Subject: Issuance of Amendment No.45 to Facility Operating
License NPF-12 Virgil C. Summer Nuclear Station,
Unit No. 1

The amendment modifies the Technical Specifications to reflect a 1.9% reduction in thermal design flow. The amendment is effective seven days after its date of issuance.

SAFETY EVALUATION BY THE OFFICE OF NUCLEAR REACTOR REGULATION
RELATED TO AMENDMENT NO. 45 TO FACILITY OPERATING LICENSE NPF-12

Figure 2.1-1 Reactor Core Safety Limit - Three Loops in Operation

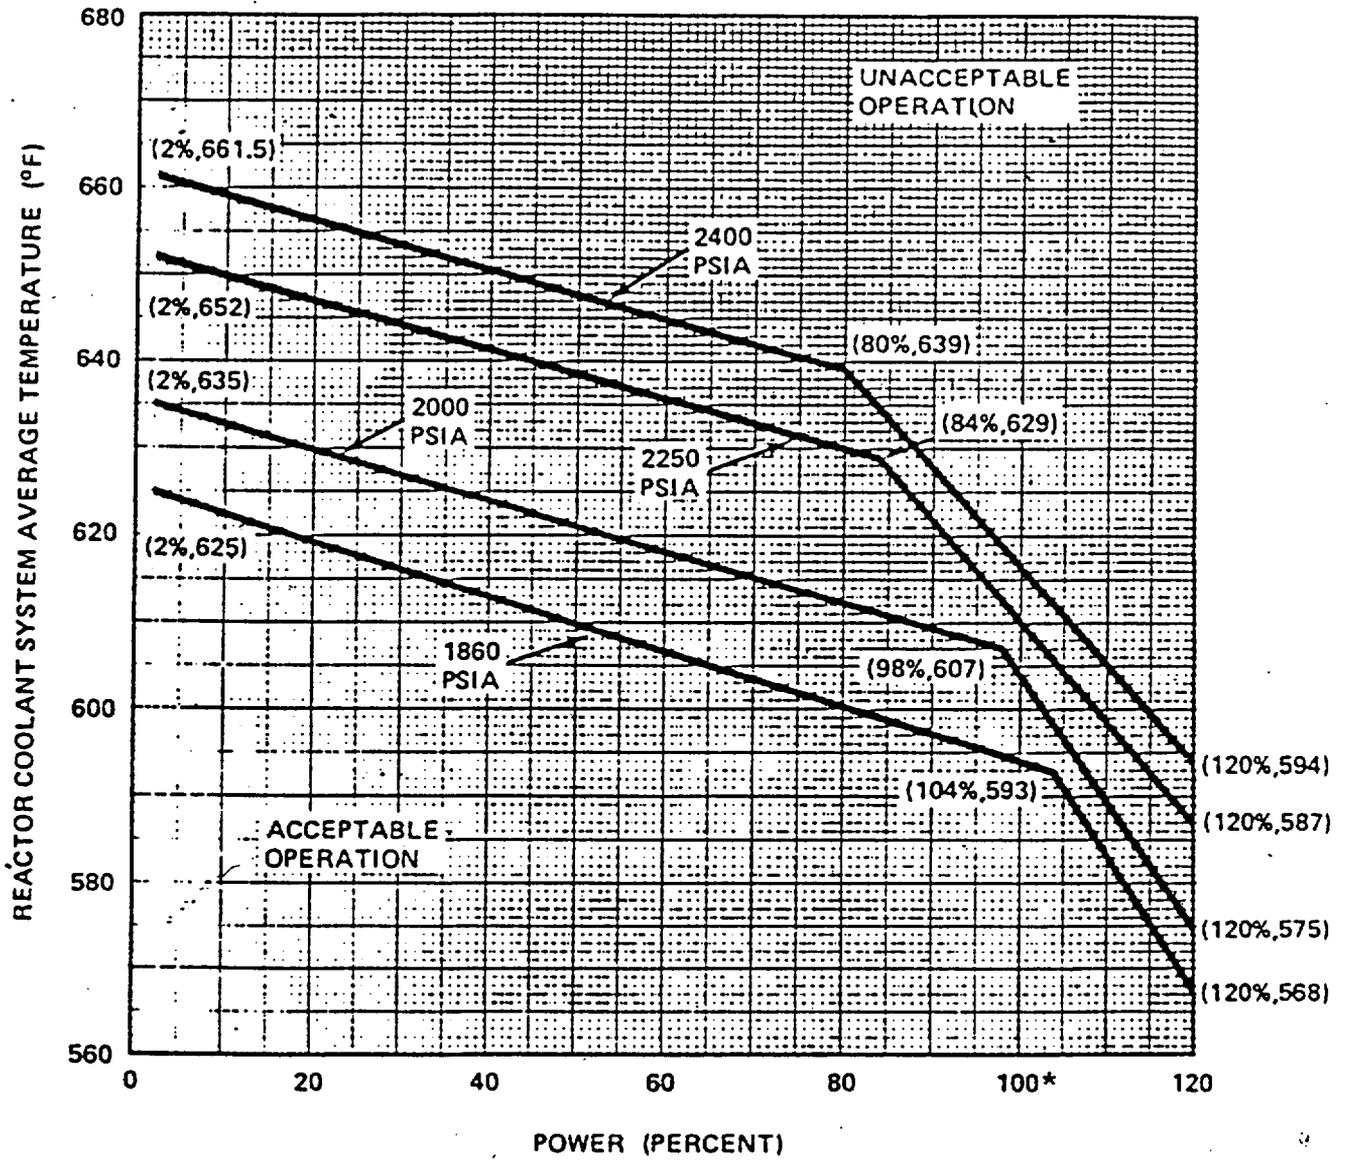
Changes in pages B3/4.2-4, B3/4.2-5, 3/4.2-8, 3/4.2-9, 2-2 and 3/4.2-11 are editorial. The changes are consistent with the changes related to the removal of dependence of operating band on rod bow penalty (as shown in Figure 3.2-3) and are acceptable.

FIGURE 3.2-3 RCS TOTAL FLOW RATE VS. R THREE LOOP OPERATION

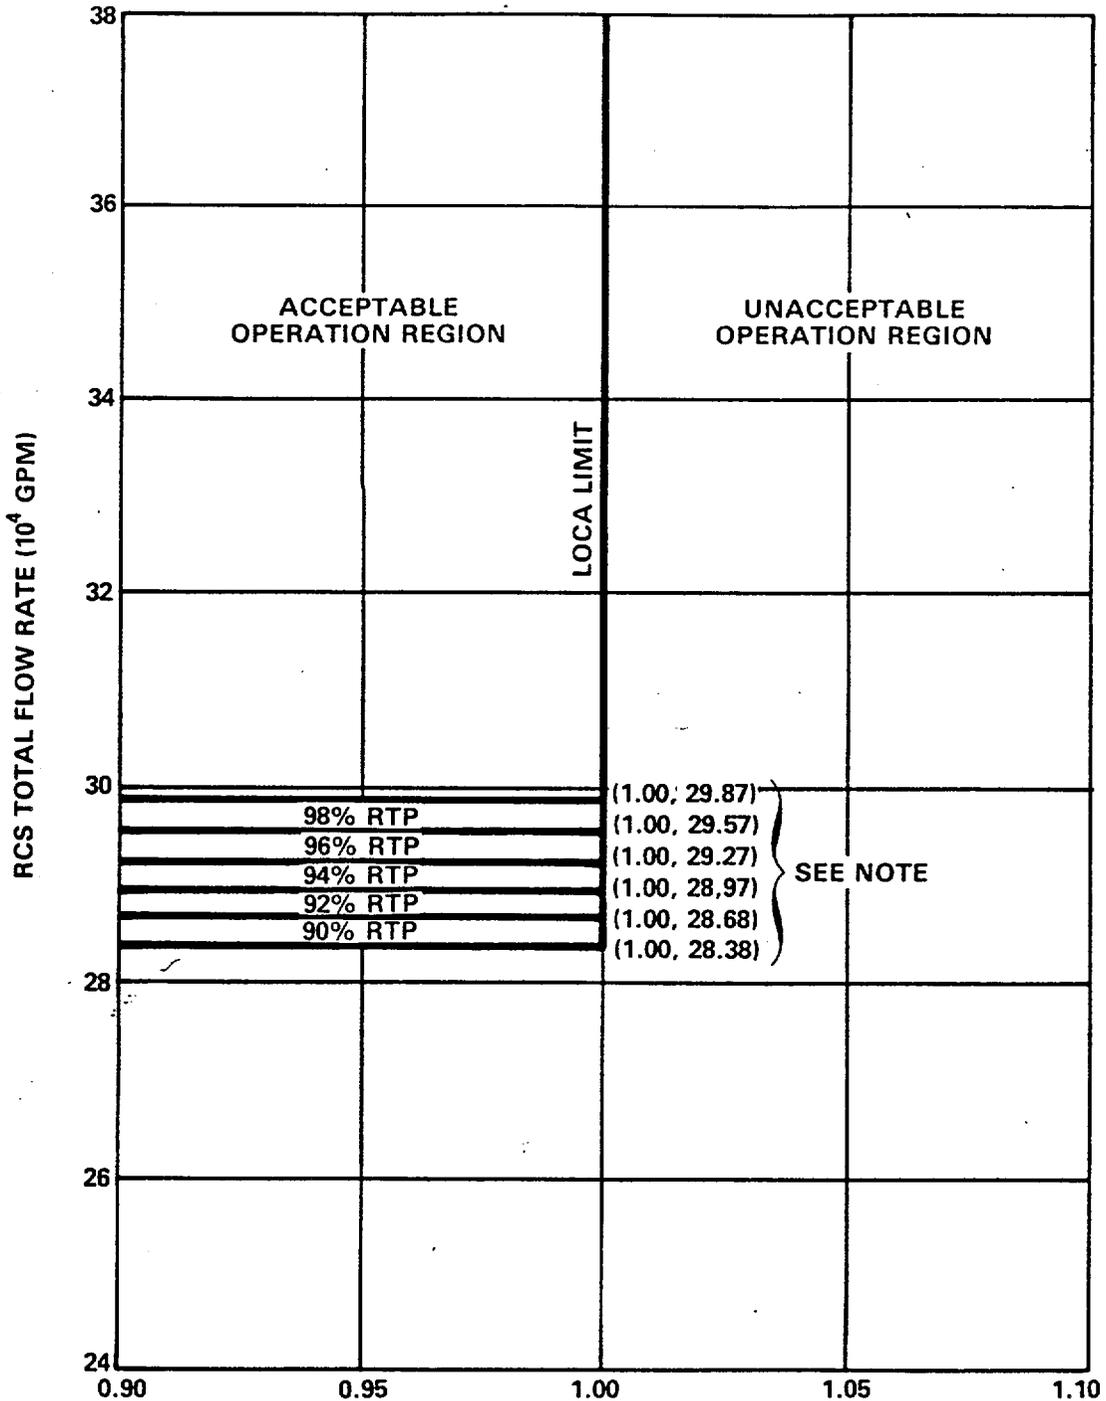
Figure 3.2-3

This figure has been modified to remove the operating area which has the dependence of operating power and reactor coolant flow on rod bow penalty. The changes cause the operating band to be more restrictive compared with the previously approved operating band and the changes are acceptable.
